Glitch & Fix, May 2018

## Drawings Have Consequences

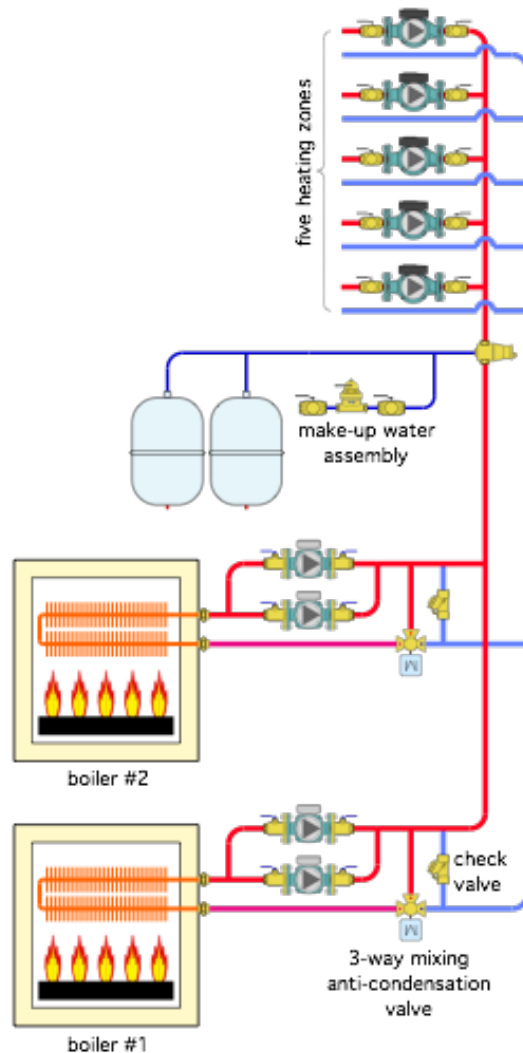
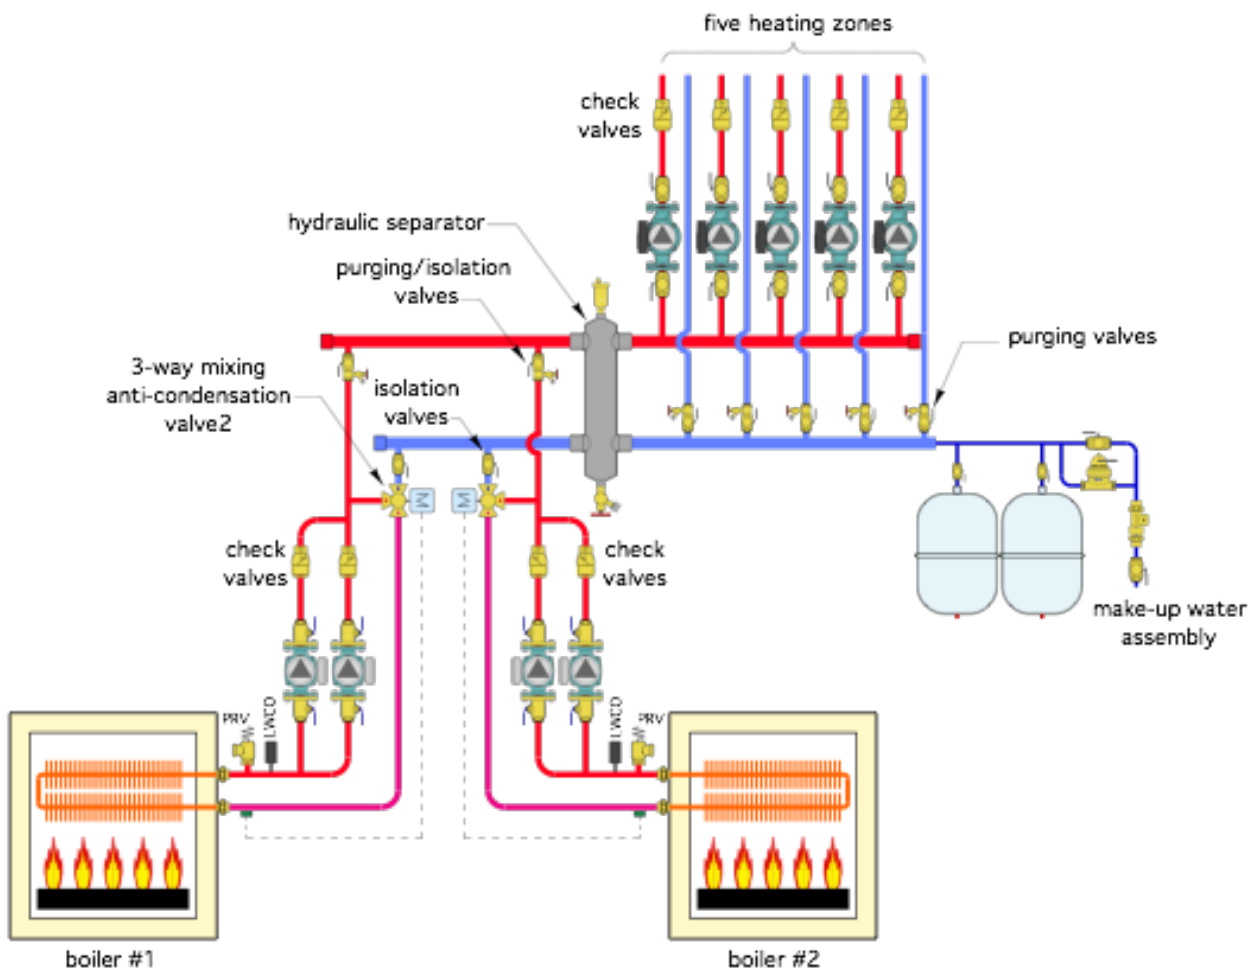
The schematic below was drawn based on my best “interpretation” of a marginally detailed CAD drawing from an engineer. The system shows two low mass conventional boilers with redundant circulators serving a 5 zone distribution system. Each boiler has a 3-way motorized mixing valve for anti-condensation control. Can you spot few details that are incorrect? What, if anything, would you recommend be changed on this drawing.

In the original drawing there are several issues that are either errors or omissions:

1. There are no check valves shown on the boiler circulators or zone circulators. Check valves are needed in any situation where multiple parallel circulators share a common header.

2. The zone circulators are shown pumping *into* the supply header. It's likely someone was cutting and pasting schematic symbols and just forgot to flip the circulator symbols when they placed them.

3. Assuming that the zone circulators were meant to pump away from the supply header, they would then be in series with the boiler circulators (not desirable). I'm *guessing* that the check valves shown on each boiler piping detail were intended to bypass flow when the total zone flow rate exceeded the boiler flow rate. If not, I don't see any purpose for these check valves.

4. There are no purging valves shown on the return piping from each zone. Without them it's going to be difficult to get the air out of this system.
5. There's no backflow preventer shown on the make up water system.

6. There are no pressure relief valves or low water cutoffs shown on the boilers.

7. There are no valves for isolating each boiler if necessary for service.

8. There's no indication of piping sizes, by notes or line width. It might be covered in the specifications, but it never hurts to be redundant when communicating information that involves thousands of dollars worth of hardware.

There are several possible ways in which this system could be modified. One possibility is shown below.

A low water cutoff, pressure relief valve have been added to each boiler. Each boiler circulator also has an associated check valve to prevent flow reversal the the inactive circulator when the other circulator is on. A 3-way motorized mixing valve is used to provide anti-condensation

protection for each boiler. Isolation and purging valves have been installed on each boiler piping assembly to allow efficient bulk air removal and isolation of each boiler if necessary.

The boilers connect to short and generously sized headers that lead to a hydraulic separator. The latter isolates the pressure dynamics of the boiler circulators from those of the zone circulators. It also provide air separation and dirt separation.

Each zone circuit is now equipped with a check valve and purging valve.

The make-up water system includes a backflow preventer and fast fill bypass valve. It connects to the end of another short generously sized header that collects the return flow from the zones and routes it back to the hydraulic separator.
